L-2001-036
10 CFR 50.80
10 CFR 50.90

Re: St. Lucie Units 1 and 2
Docket Nos. 50-335, 50-389
Turkey Point Units 3 and 4
Docket Nos. 50-250, 50-251
Application for Order and Conforming License Amendments
Transfer of Operating Authority

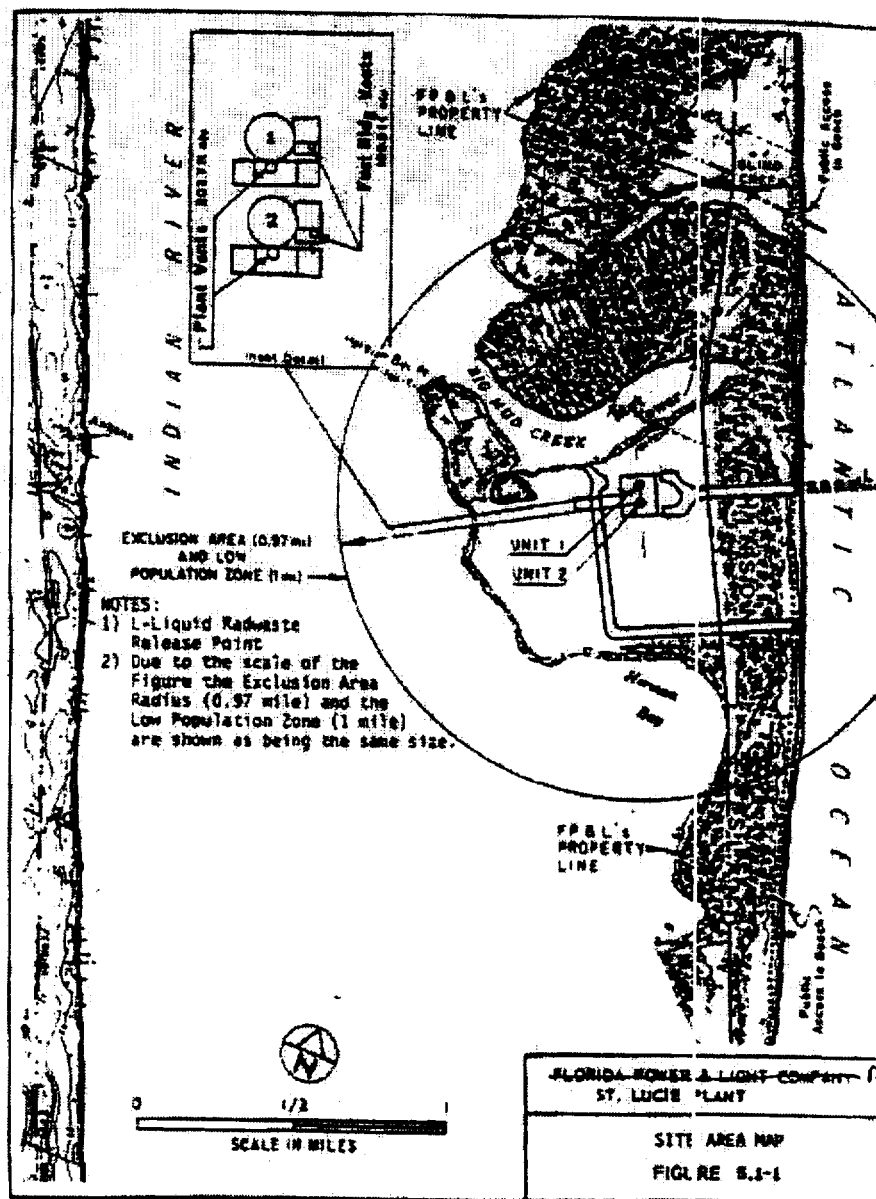
4. Revise TS 4.7.9.1.1.a. to change [The licensee] to [WCB]
 5. Revise TS Figure 5.1-1 to delete reference to [Florida Power & Light Company] in the Figure title box

- a. The licensee, or *EWCB*
- b. Other persons specifically authorized by the Commission or an Agreement State.

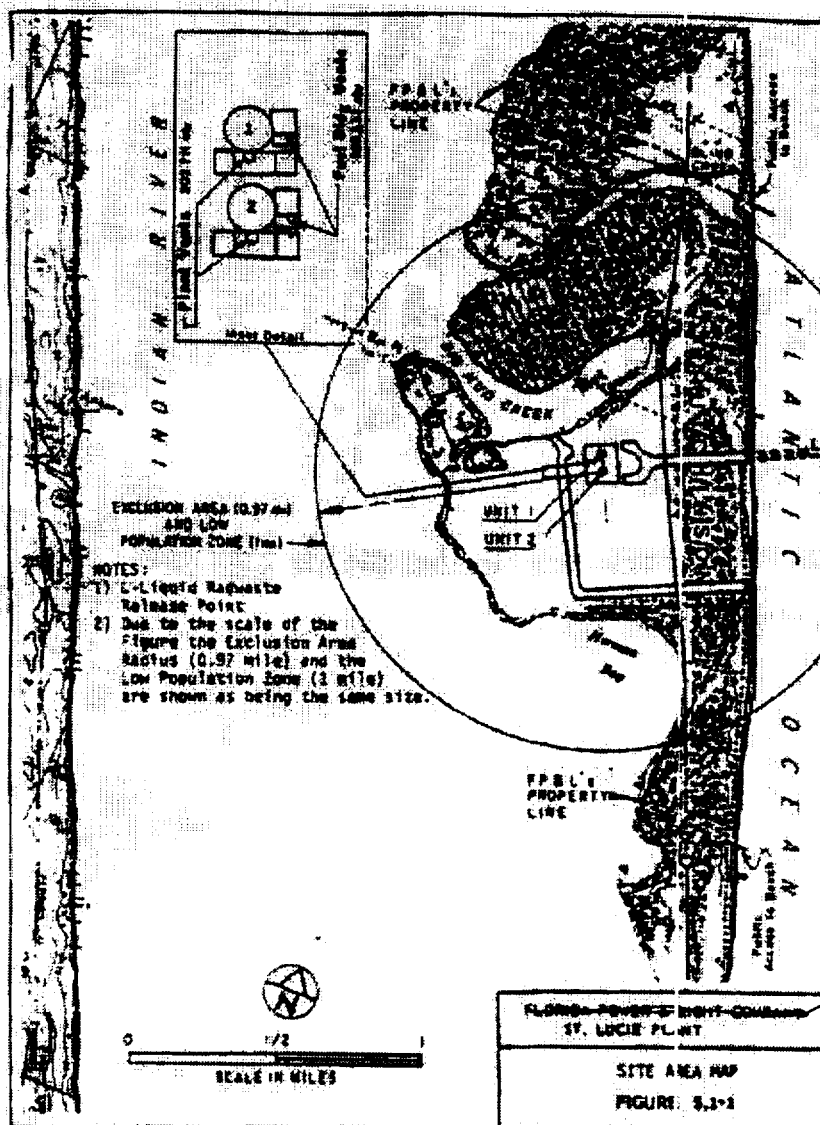
4. Revise TS 4.7.10.1.a. to change [The licensee] to [WCB]
 5. Revise TS Figure 5.1-1 to delete reference to [Florida Power & Light Company] in the Figure title box

- a. ~~The licensee~~ or ^{WCB}
- b. Other persons specifically authorized by the Commission or an Agreement State.
